## ANTARES CHARTS CORRECTIONS AND CAUTIONS 2021

### ***Issues relating to charts in the current 2020 set:***

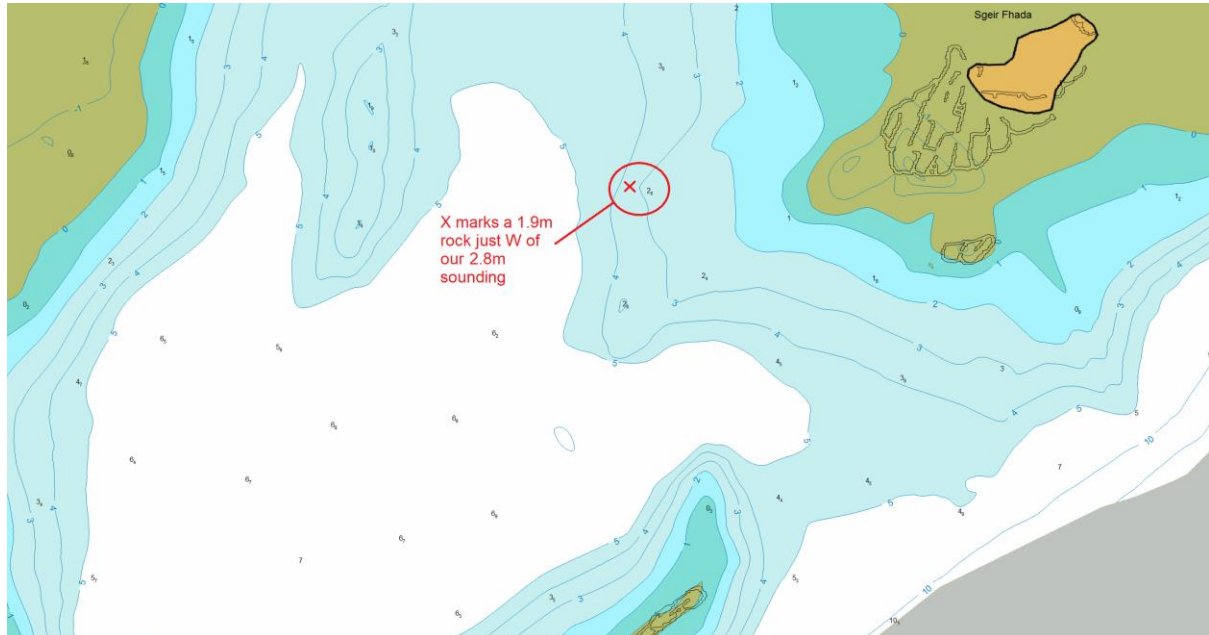
**April 2020 and June 2021: Correction to a correction!: Chart 5724A, edition 2, Lochcarron Bay:** a professional survey in early 2020 reported a 1.9m rock in an area we show as over 3m and close to a 2.8m sounding. The position is 57deg 23.78N, 5deg 28.95W. See extract from our chart, below. We reported this as a correction in April 2020. In June 2021 we re-surveyed the area to find no trace of the reported rock. The UKHO has been notified.

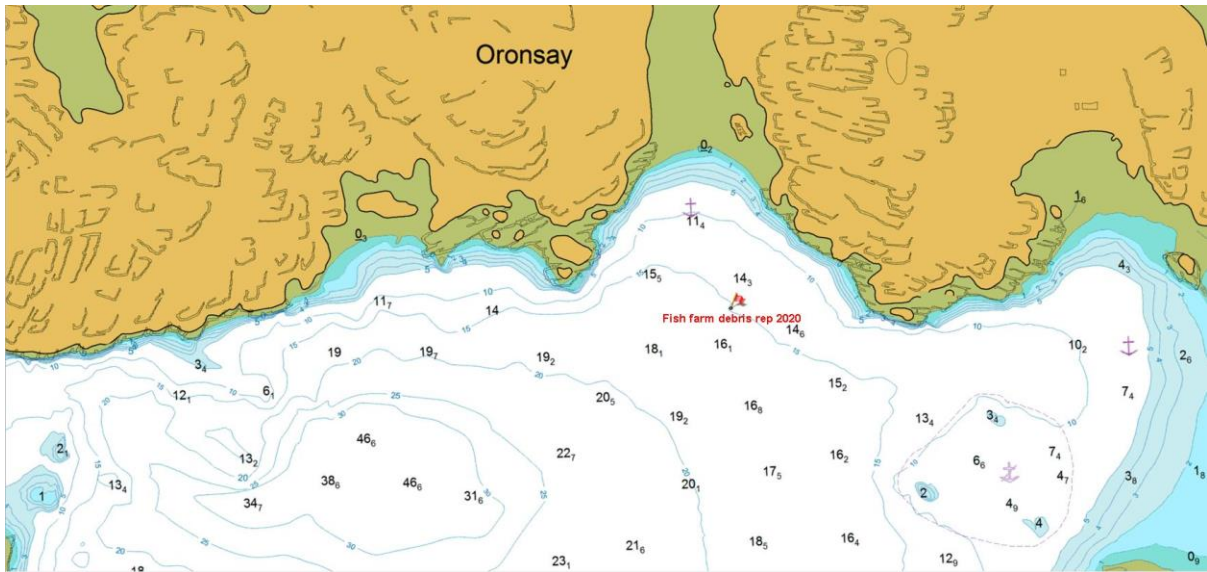
**August 2020: New hazard: Loch Drumbuie:** an Antares Charts subscriber recently reported the following serious underwater hazard: a heavy pile of fish farm debris comprising nets, steel poles and ropes - all well enough secured to the bottom to hold our vessel on a vertical rode against 30knots! Location, roughly on the 15m

contour to the north of the Loch: 56° 39.428' N 5° 55.733' W. For convenience this position is shown on the extract of our chart:
